REVIEW OF PLANS AND SPECIFICATIONS

WYOMING DEPARTMENT OF ENVIRONMENTAL QUALITY  
WATER QUALITY DIVISION  
State Office Building  
Cheyenne, Wyoming 82002

FIG. 1206.

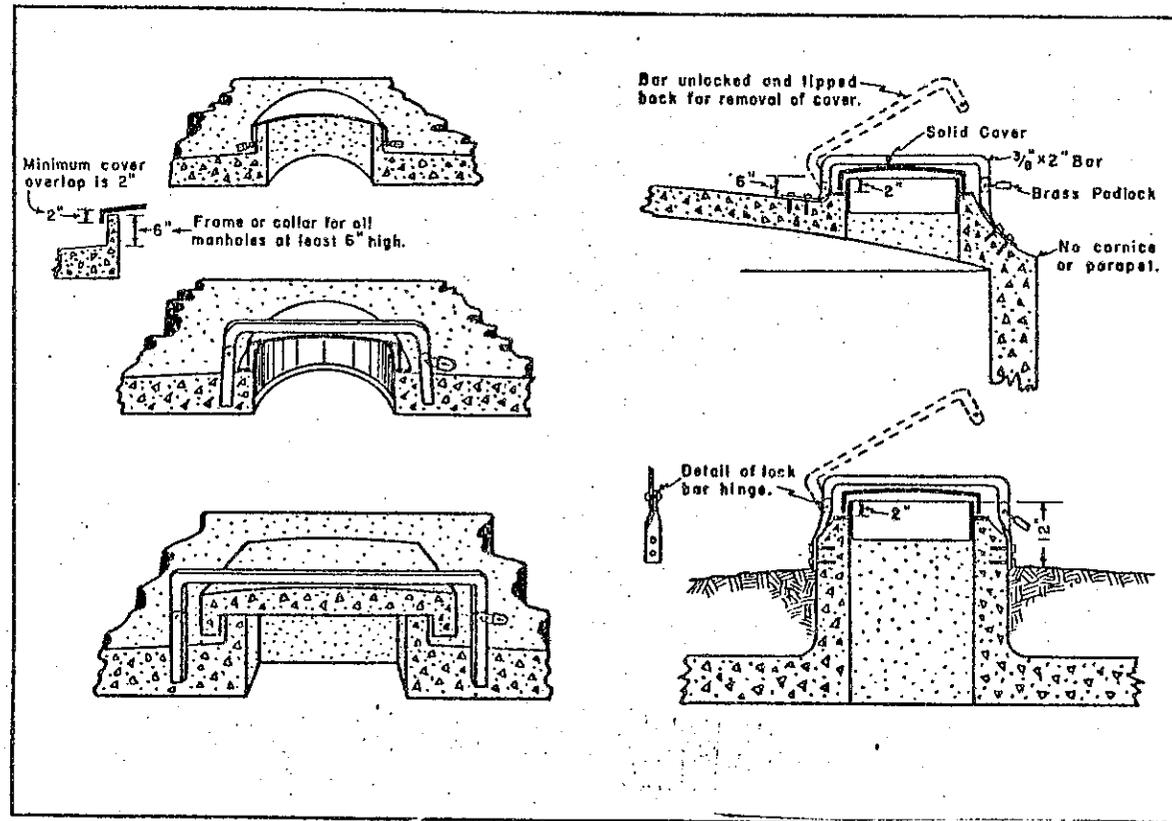
8. Specify quality of concrete and methods of construction to provide a stable, durable and permanently water tight reservoir.
  9. The reservoir manhole shall be constructed of water tight concrete poured integrally with the tank. It shall extend at least 12 inches above the pumphouse floor and be provided with a downward overlapping cover and locking device (see figure 1206, enclosed).

Fig. 707

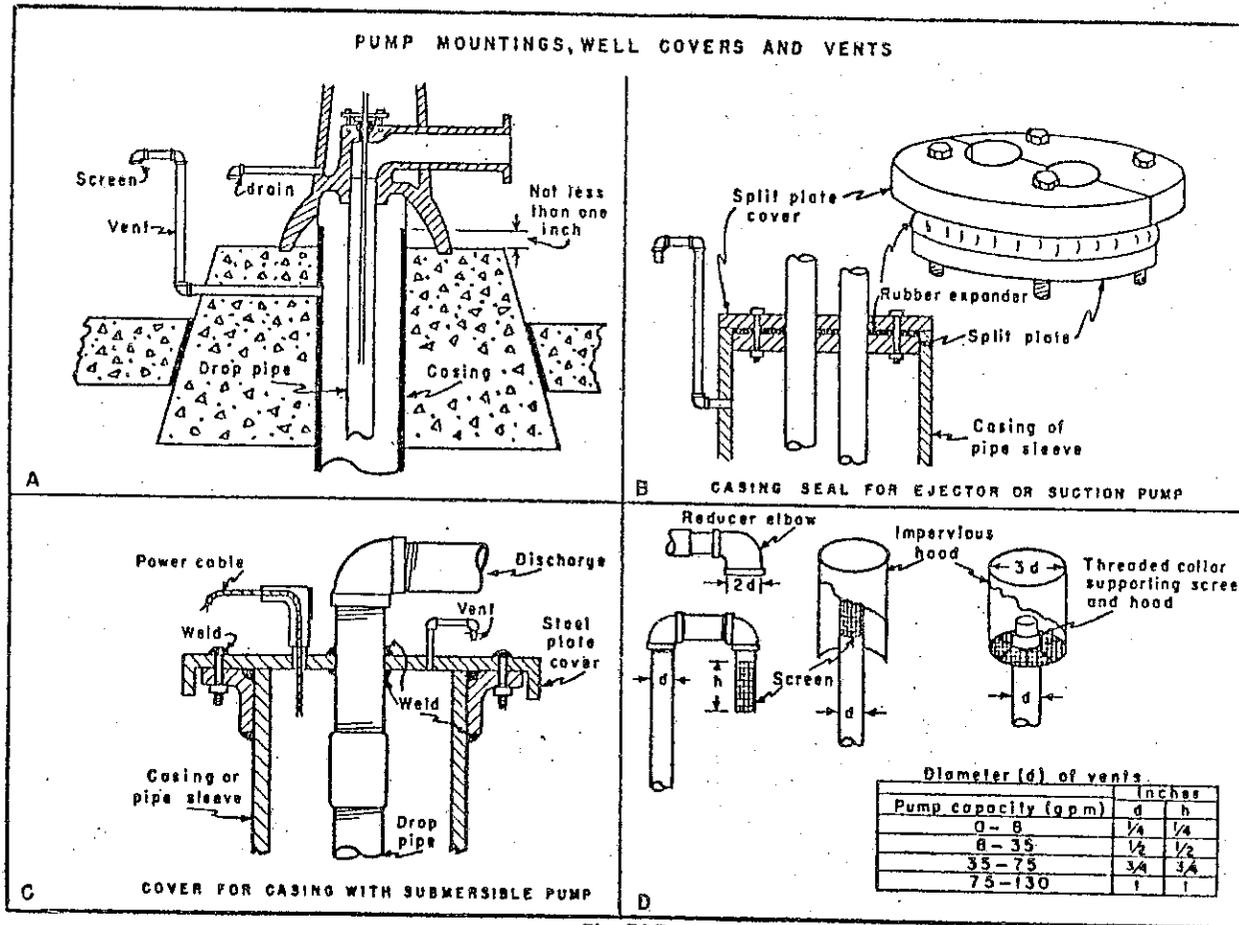
7. COMMENTS:
  1. Provide a water tight concrete grout seal at least 6 inches thick around the well curbing. The grout shall extend from a point at least 6 inches above the pump-house floor level to a point at least 10 feet below the surface of the ground. (See Bored Well, fig 702 enclosed.)

2. The concrete well cap shall extend downward a distance of at least 2 inches around the outside edges of the well curbing (see figure 702).
  3. Submit a detail of the well pump setting with pipe sleeve cast in the concrete well cover. The pipe sleeve shall extend at least one inch up into the pump base if a vertical turbine pump is used and the pump base shall be grouted into the well cover. (See enclosed sketch, figure 702, A.)
